MIL-C-49142
AMENDMENT 2
13 September 1989
SUPERSEDING
AMENDMENT 1
10 January 1983

CONNECTORS, PLUGS AND RECEPTACLES, ELECTRICAL, TRIAXIAL,
RADIO FREQUENCY,
GENERAL SPECIFICATION FOR

This amendment forms a part of MIL-C-49142, dated 17 April 1978, and is approved for use by all Departments and Agencies of the Department of Defense.

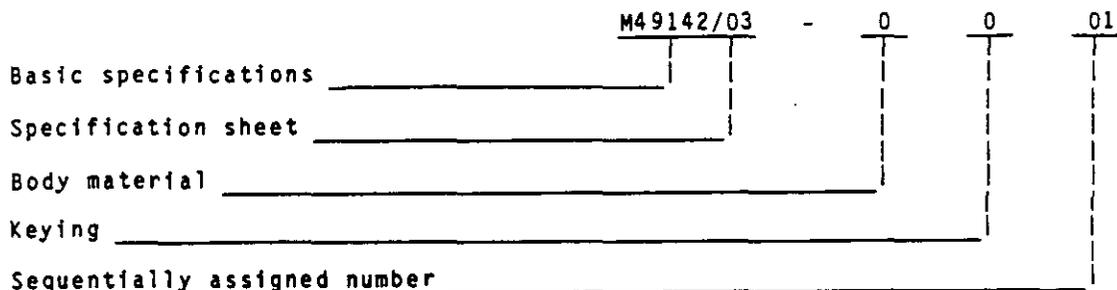
* 1.2.2, delete and substitute:

"1.2.2 Part or Identifying Number (PIN). The PIN shall consist of the letter "M" followed by the basic specification sheet number and a four digit dash number. The first digit of the dash number designates the material of the connector body (shell); "0" for brass and "3" for corrosion resistant steel. The second digit of the dash number designates modified bayonet coupling mechanism keying when applicable (see figure 1). The third and fourth digits of the dash number are sequentially assigned.

FIGURE 1. Keying configurations (TRB only).

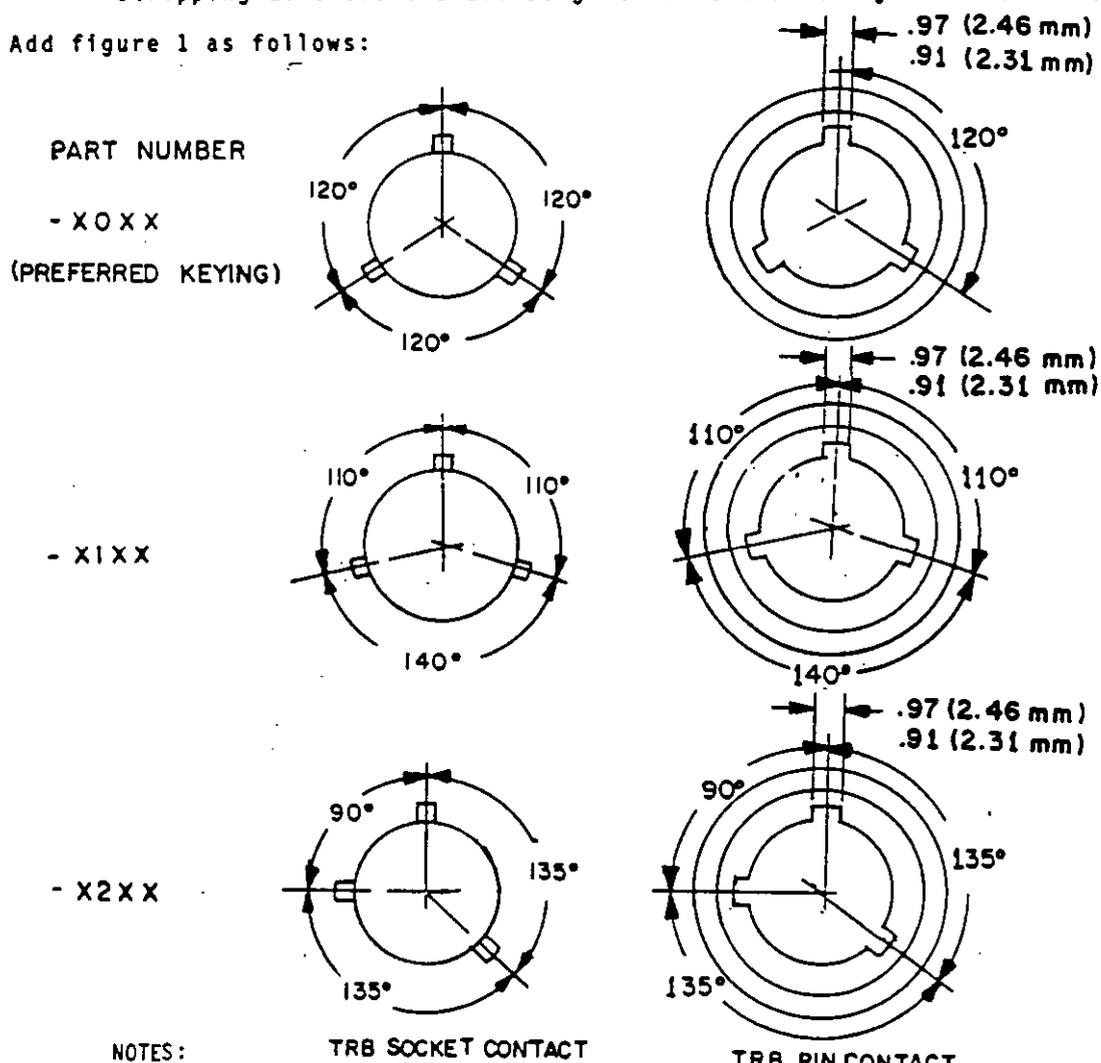
* Add figure 1 as follows:

NOTES:

1. Bayonets shall be dimensioned in accordance with MIL-STD-348, unless otherwise specified.
2. Tolerance on all angles shall be $\pm 1^\circ$.
